Takes of Marine Mammals Incidental to Specified Activities; Taking Marine Mammals Incidental to an Exploration Drilling Program Near Camden Bay, Beaufort Sea, Alaska; Notice

ACTION: Notice; issuance of an incidental harassment authorization.

SUMMARY: In accordance with the Marine Mammal Protection Act (MMPA) regulations, notification is hereby given that NMFS has issued an Incidental Harassment Authorization (IHA) to Shell Offshore Inc. (Shell) to take marine mammals, by harassment, incidental to offshore exploration drilling on Outer Continental Shelf (OCS) leases in the Beaufort Sea, Alaska.

Figure 1. Band levels for the Kulluk during drilling.

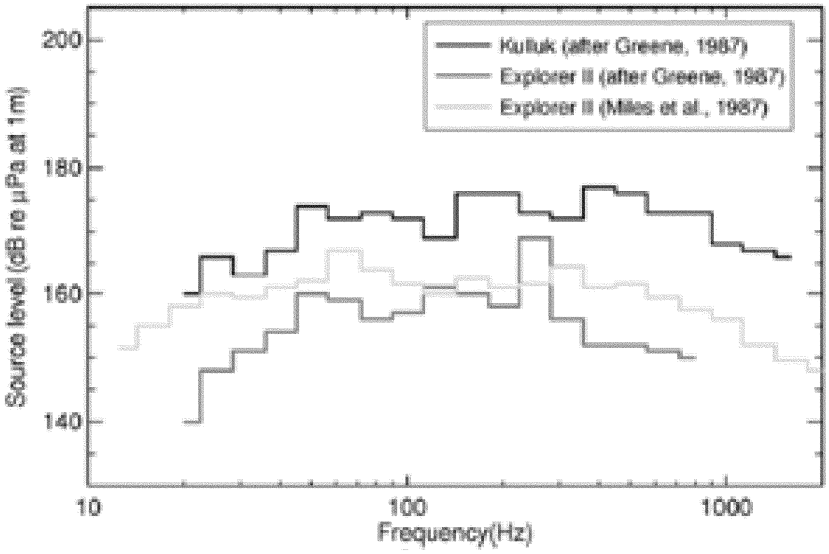
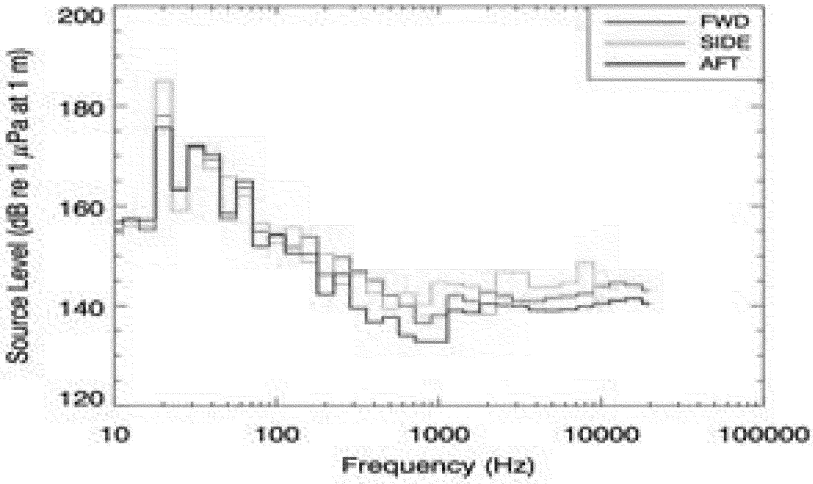
Comment 4: The MMC and AWL question the source levels and harassment zones for the two drillships. If the source levels for the *Kulluk* and *Discoverer* are nearly identical, then why is there a four-fold difference in the size of the corrected harassment zones for the two drilling vessels?

Response: Differences in sound propagation from the two rigs are real and are caused by differences in the design of the two vessels. While the broadband source levels for the *Discoverer* and *Kulluk* may be similar, their spectral properties differ considerably. Acoustic modeling considers the source levels in 1/3-octave frequency bands. Figures 1 and 2 show the band levels for both drillships during drilling. Of key importance are the significantly lower levels of the *Discoverer* in the 50 to 500 Hz bands that propagate well in the relatively shallow waters of these drilling operations. While the *Discoverer* apparently has higher band levels below 50 Hz, this energy is more rapidly attenuated than higher frequency sound energy. This characteristic of sound propagation in shallow waters leads to predominantly mid-frequency sounds (50–500 Hz) dominating the acoustic field at distance from the drillships. A further consideration is that the *Kulluk* source levels are known to include contributions from support vessels, and much of the mid-high frequency band energy in its source levels may not originate entirely from the drillship itself, as acknowledged by Greene (1987). The *Discoverer* source level measurements by Austin and Warner (2010) were made at closer distances and do not include significant contributions from other vessels. The *Kulluk's* modeled sound footprint may be an overestimate as a result, but we cannot quantify by how much since the relative contribution of vessel noise to its source level measurements is unknown. The source level for the *Discoverer* was measured, though not in the Beaufort Sea, and those measurements were used to model propagation in the Beaufort Sea environment. Regardless of which drill rig is used by Shell in the Beaufort Sea in 2012, the IHA requires Shell to conduct sound source verification (SSV) and characterization tests on all equipment used.

Figure 3. Sound speed profile used in drill rig modeling.

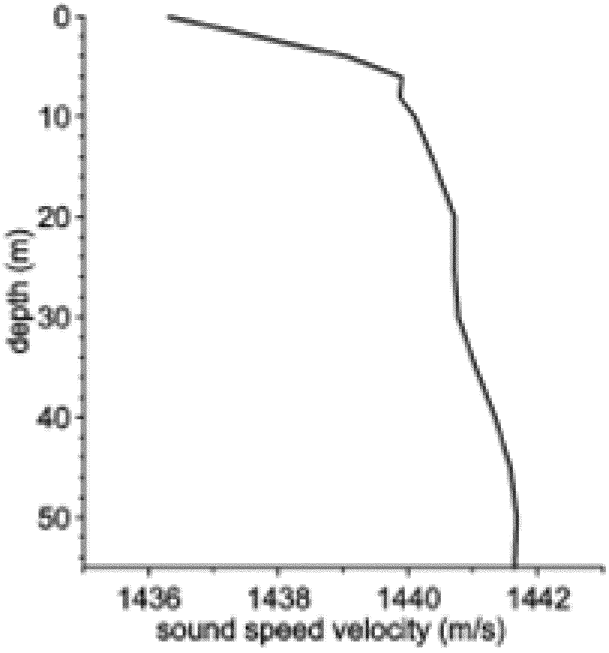
Comment 26: Dr. Bain states that the correction factor of 1.5 applied to the distance to the 120 dB contour is inadequate to conservatively account for the variability.

Response: The concern raised here is that the sound speed profile used for acoustic modeling of drill rig noise may not account for changes to the salinity and temperature profile that could influence and create variability in sound propagation, and the resulting variability might lead to conditions in which model estimates would not be conservative. While significant structure can form in the sound speed profile, the profile used for this modeling study was taken from the GDEM database for the corresponding locations and timing (month of September was used). The specific profile chosen (see Figure 3) has increasing sound speed with depth over the full water column. This profile leads to upward acoustic refraction that causes propagating sounds to bend up, thereby reducing interactions with the seabed. This situation generally reduces acoustic transmission loss as a result of acoustic energy being lost due to reflection and scattering from the bottom. It is believed to produce longer propagation distances than the stratified profile that sometimes forms with warmer high speed water overlying cooler water. That profile would be downward-refracting and would lead to more bottom interaction and sound energy loss. Therefore, a correction factor of 1.5 is appropriate in this circumstance.
